Questions to
Study on sound level limits of M-and N-
category vehicles
on TFVS-09-06 and TFVS-07-11

10th TFVS meeting
12. July 2022

JAPAN AUTOMOBILE STANDARDS INTERNATIONALIZATION CENTER

Fig26 @TFVS-09-20 Fig72 @TFVS-07-11

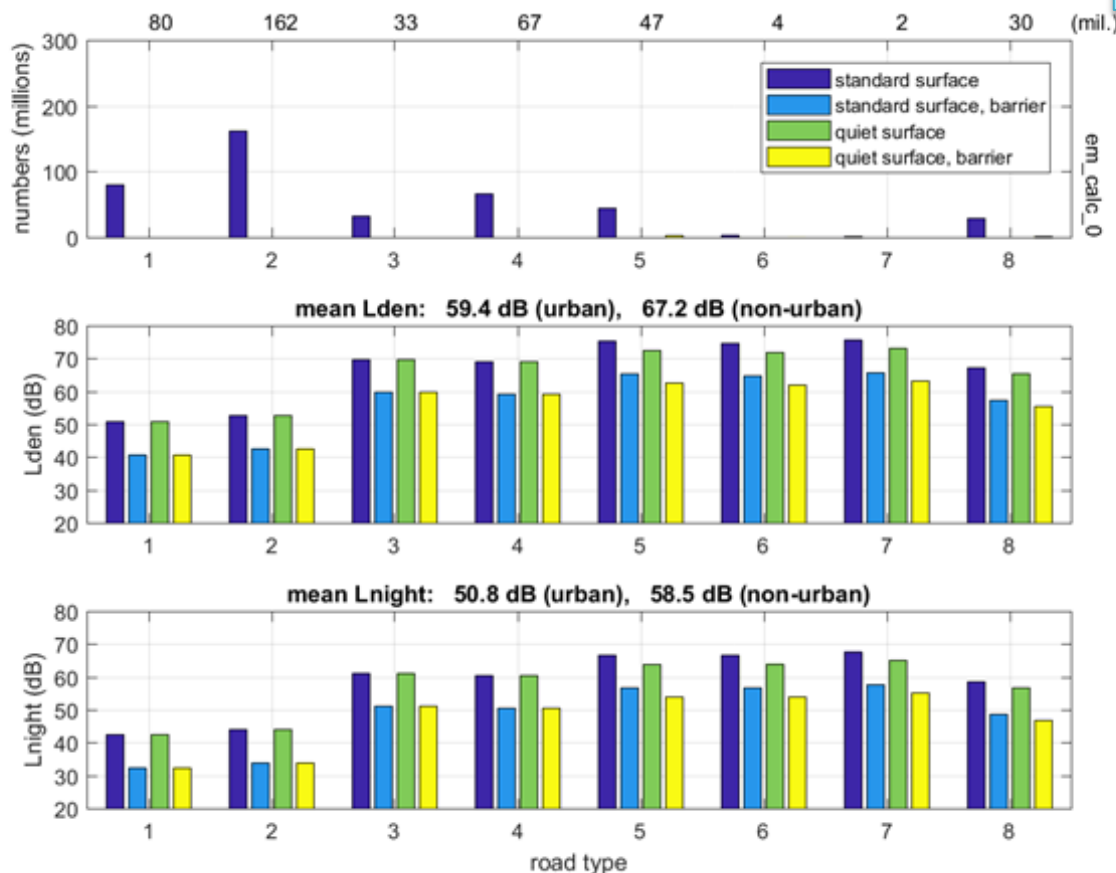
Question;
 What is the standard road surface?
 What is the quiet road surface?

Information;
 COMMISSION DIRECTIVE (EU) 2015/996 — a virtual reference road surface, consisting of an average of dense asphalt concrete 0/11 and stone mastic asphalt 0/11, between 2 and 7 years old and in a representative maintenance condition

Fig26 @TFVS-09-20 Fig72 @TFVS-07-11

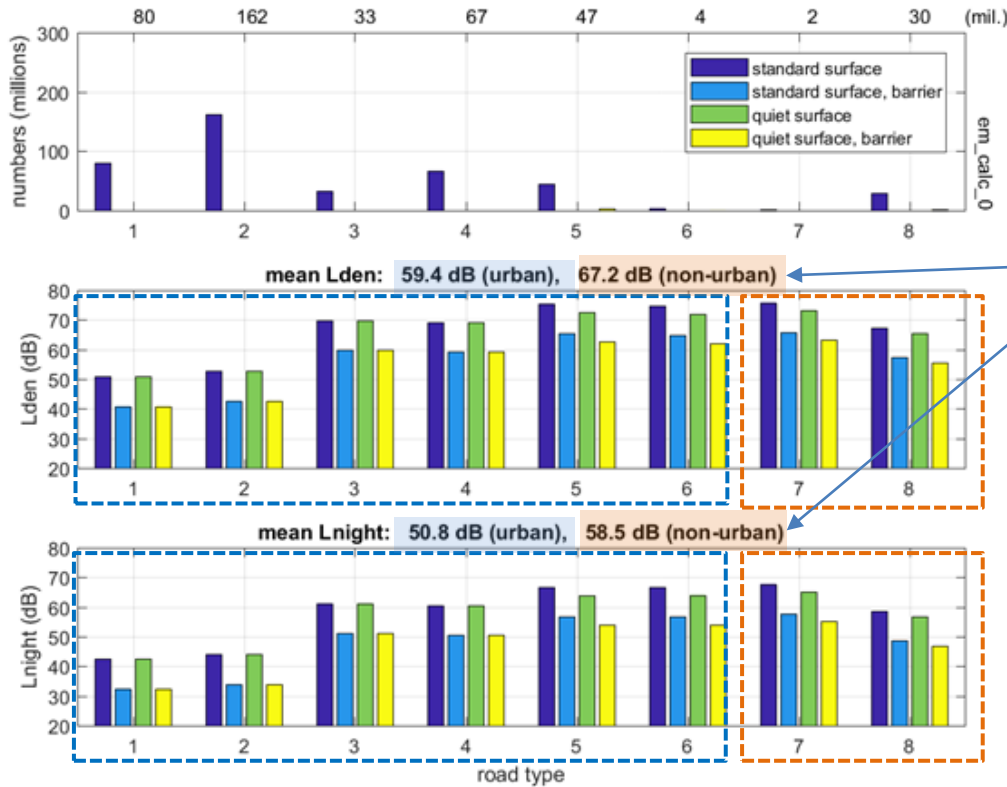
Question;
How to calculate the mean value of Lden and Lnight with different road types?

A low percentage of quiet road surface is assumed for roads ≥ 50 km/h of around 5%, this is included in the calculation
